**ELECTRICITY INDUSTRY PARTICIPATION CODE  
DISTRIBUTED UNMETERED LOAD AUDIT REPORT**

**NZTA TAUPO  
AND  
TRUSTPOWER LIMITED (CNIR)  
NZBN: 9429038917912**

Prepared by: Rebecca Elliot

Date audit report completed: 4 May 2022

RDC Boundary

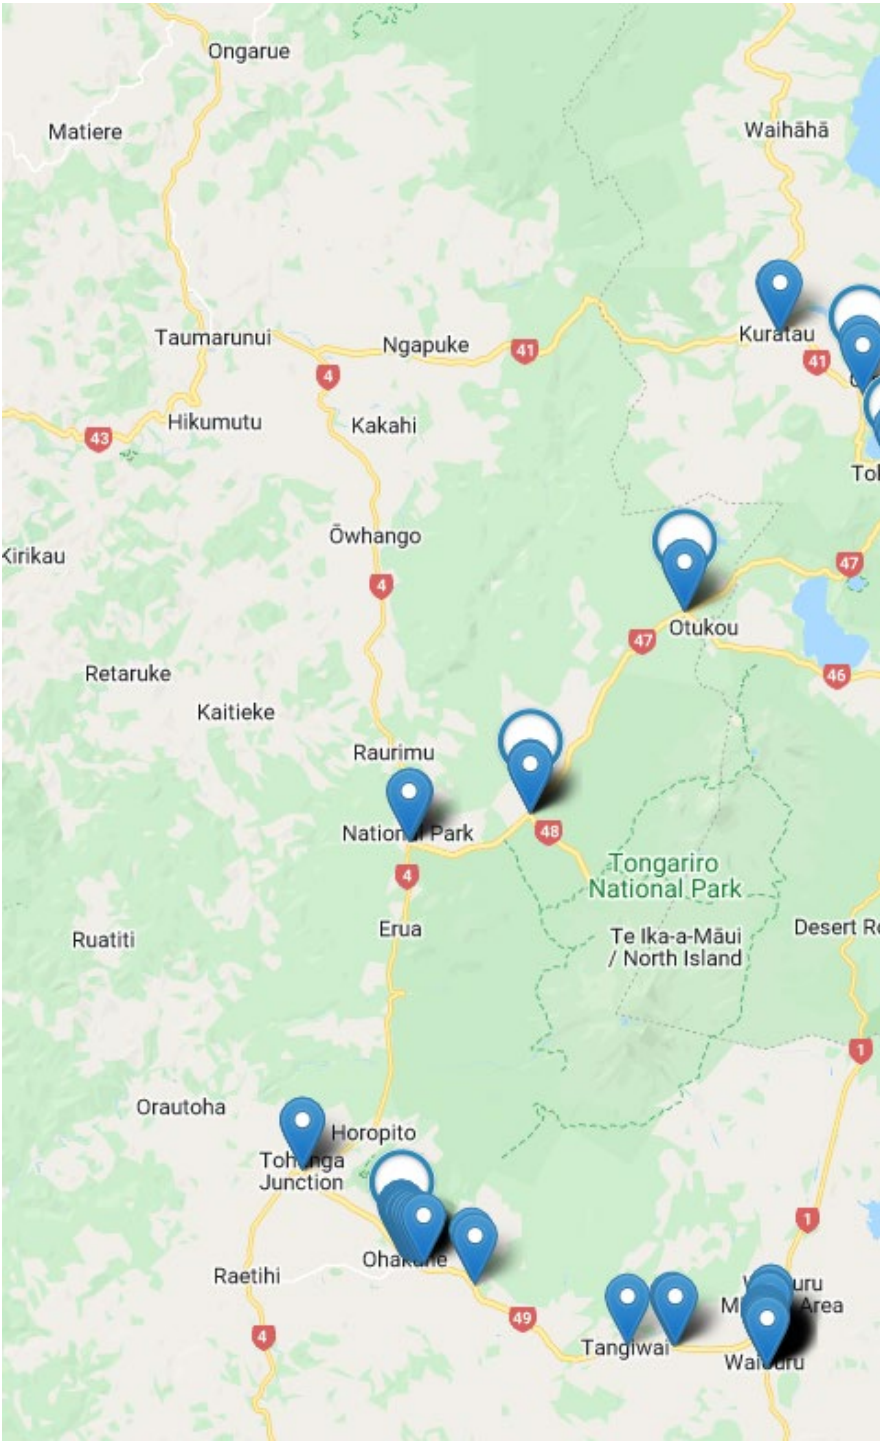
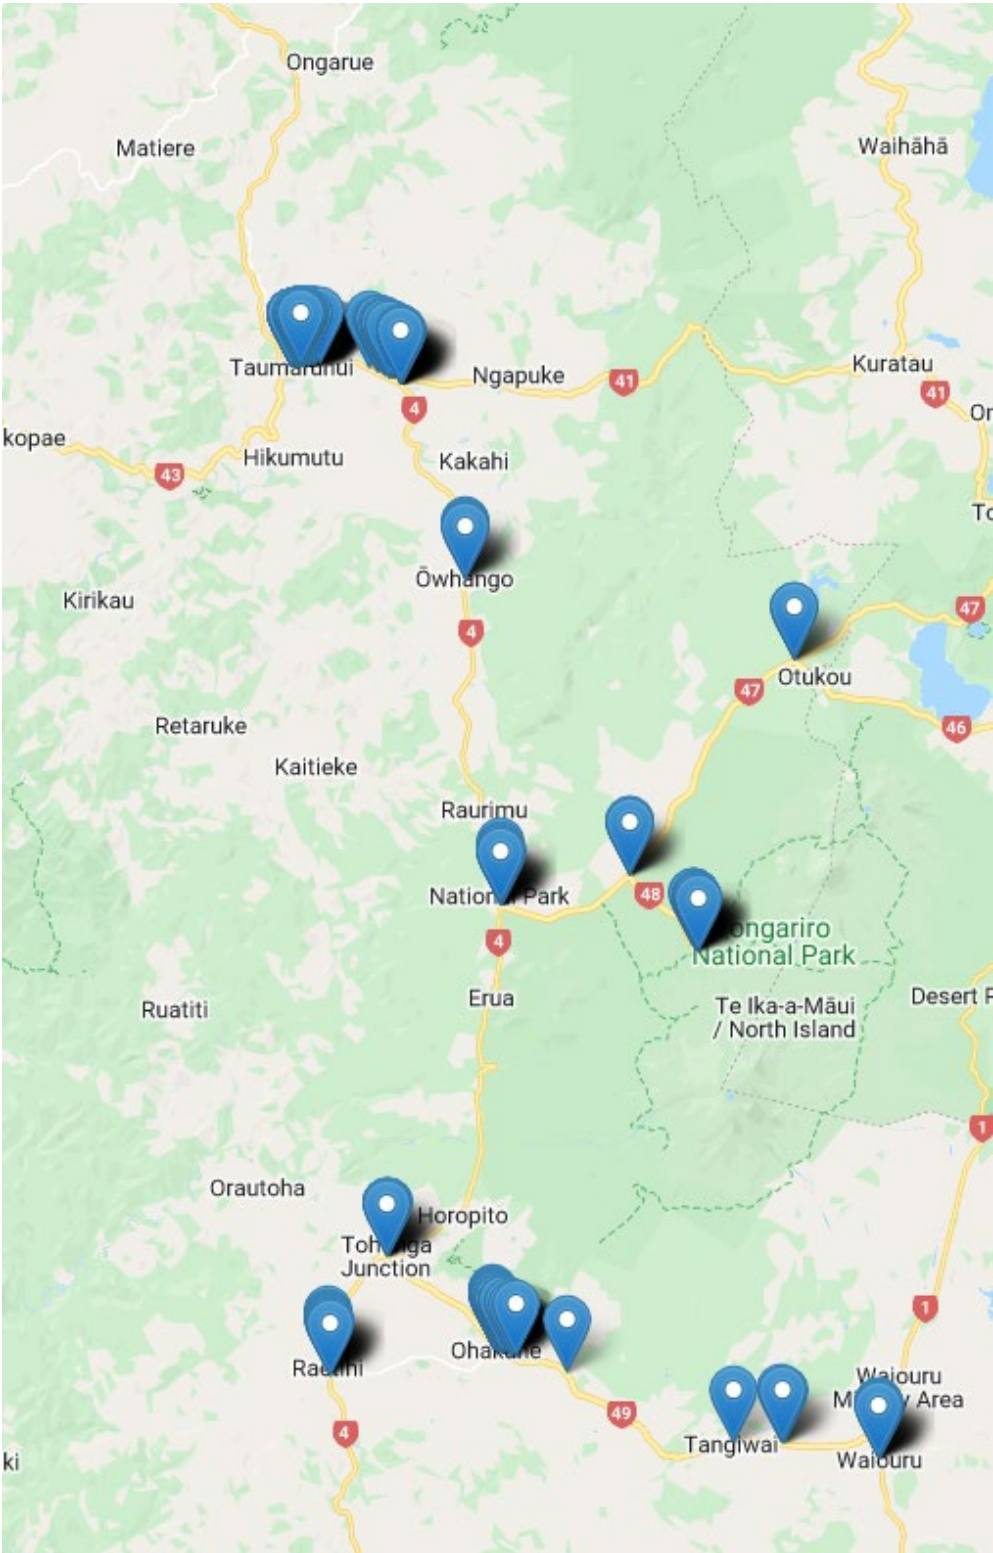
In addition to this it appears that there are 209 NZTA lights in the Ruapehu DC & Taupo DC areas that are being reconciled by both the councils and NZTA resulting in potentially 36.63 kW or 156,434 kWh per annum of load being submitted twice. The duplicated lights have been provided to WSP to investigate. I have included detailed pictures below showing the council boundaries, the NZTA RAMM database lights and the RDC SH lights:

I recommend that CNIR liaise with local councils and NZTA to determine the correct lights to be recorded in this database.
